**BULLETIN NO. 121306**

TITLE: Vent Hood/Termination Change for Sidewall Venting

PFO	All sizes

# FIGURE 1

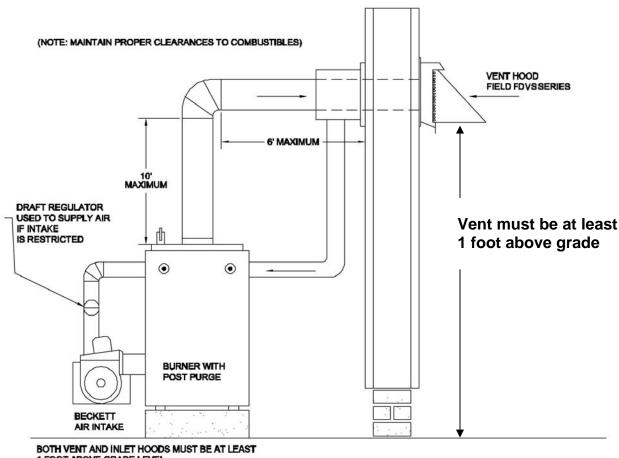
The two-piece air inlet and vent hood termination on sidewall vented PFO series boilers has been changed to a one-piece, concentric termination (see figures 1 & 2). This new "concentric" style vent termination results in easier, more flexible installation, improved performance and increased durability:

- The required number of "Through the wall" exterior openings are reduced from two to one.
- There is zero clearance to combustibles (Concentric Termination Only).
- The Combustion Air Tee can be rotated 180 degrees (see figure 1).
- The concentric termination features 40 mph wind resistance.
- The potential for flue gas recirculation into the air inlet and blocked air inlet conditions (i.e. due to snow), are reduced.
- The new concentric termination features durable 316 stainless steel construction.
